**BAY FOREST PARK SUBDIVISION, RESUBDIVISION**  
**OF LOTS 6 & 7 AND BAY FOREST PARK**  
**SUBDIVISION LOT 10, OF THE RESUBDIVISION OF**  
**LOTS 9 & 10**

APPLICATION NUMBER 5 DATE October 5, 2017

REQUEST Subdivision

# DETAIL SITE PLAN

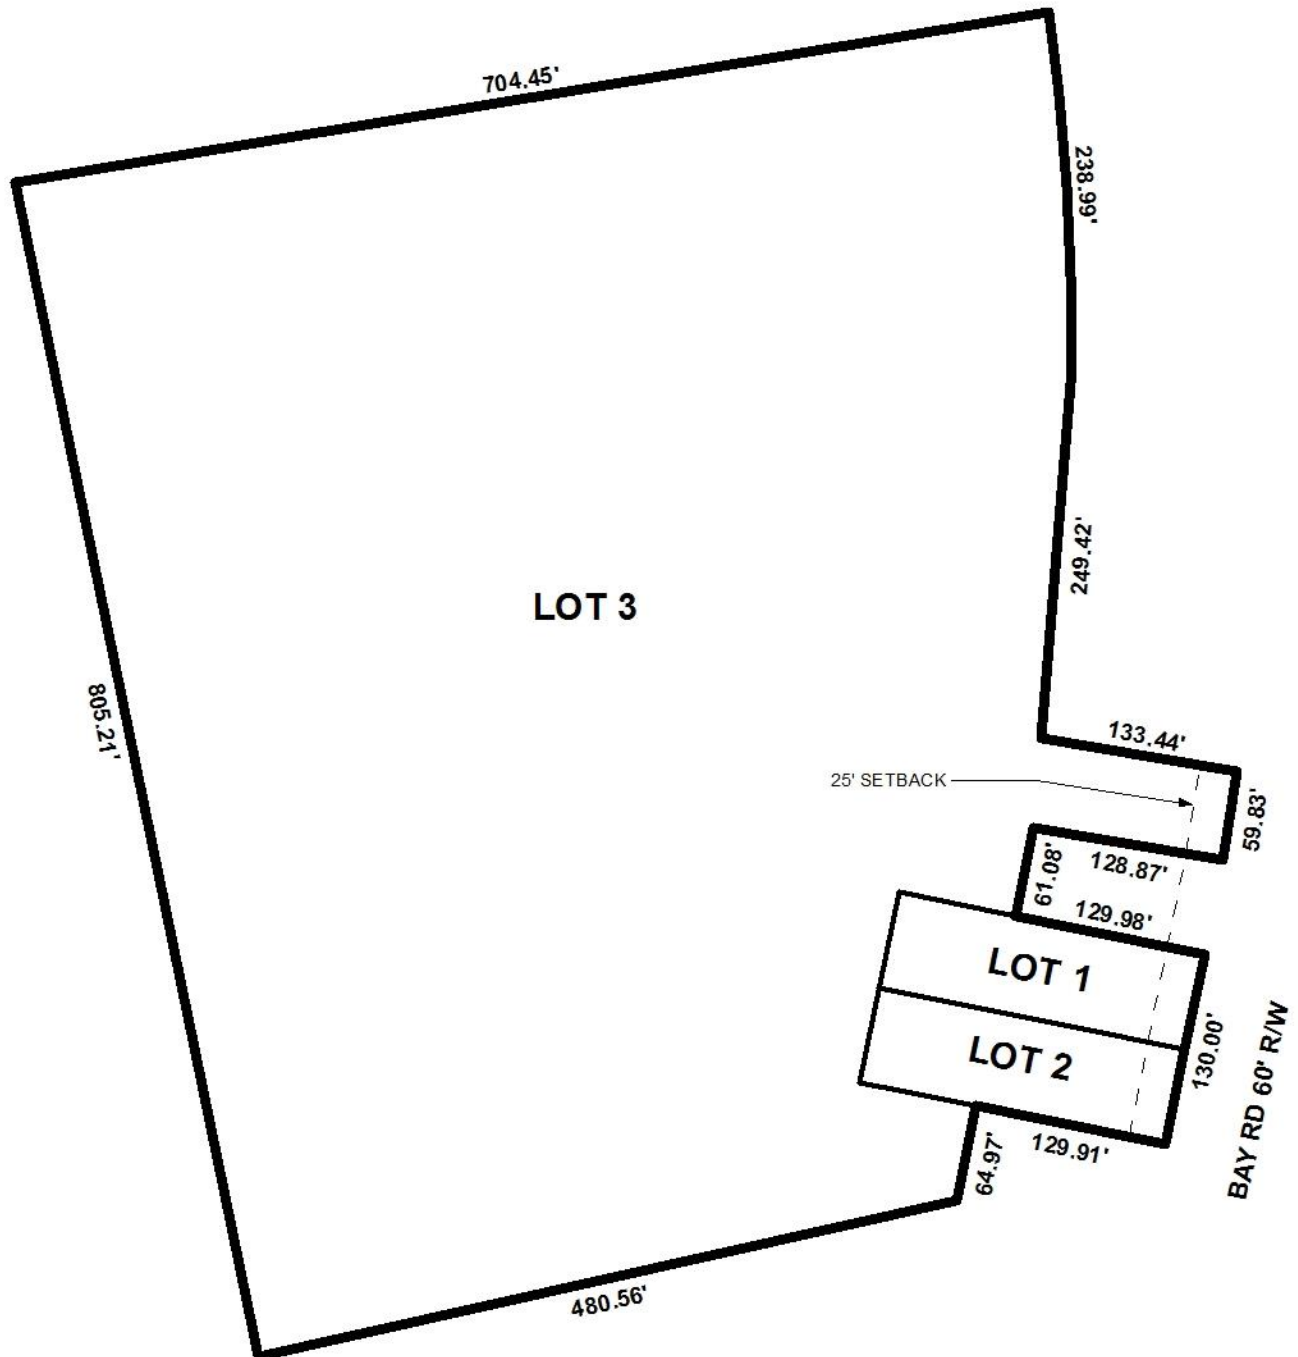
The proposed lots front Bay Road, a minor street without curb and gutter. As a minor street without curb and gutter, this street requires a 60' wide right-of-way width. The existing right-of-way width is depicted as 60' on the preliminary plat and should be retained on the Final Plat, if approved.

The proposed Lot 3 has a flag lot configuration with a 59'± wide pole connecting the property to the street. As the general configuration of this lot was previously approved by the Planning Commission, a waiver of Section V.D.1. of the Subdivision Regulations would be appropriate.

The 25-foot minimum building setback line is depicted on the preliminary plat for Lots 1 and 2, but not for the proposed Lot 3. If approved, the setback should be illustrated for all lots where they are a minimum of 60' wide on the Final Plat.

The lot size information is depicted in both square feet and in acres on the preliminary plat and should be retained on the Final Plat, if approved. The lots meet the minimum lot size requirements for sites with public water and sewer.

As a means of access management, a note should be placed on the Final Plat, if approved, stating that each lot is limited to one curb cut to Bay Road, with any changes to the size, design and location of the curb-cut to be approved by Mobile County Engineering and conform to AASHTO standards.

- 1) submittal of seven (7) copies of the recorded Bay Forest Park Subdivision to Planning & Zoning staff prior to the signing of the Final Plat;
- 2) retention of the 60' wide right-of-way width along Bay Road;

- 3) illustration of the 25-foot minimum setback line for all lots where they exceed 60' wide;
- 4) retention of the lot size information in both square feet and in acres;

- 5) placement of a note on the Final Plat stating each lot is limited to one curb cut to Bay Road, with any changes to the size, design and location of the curb-cuts to be approved by Mobile County Engineering and conform to AASHTO standards;
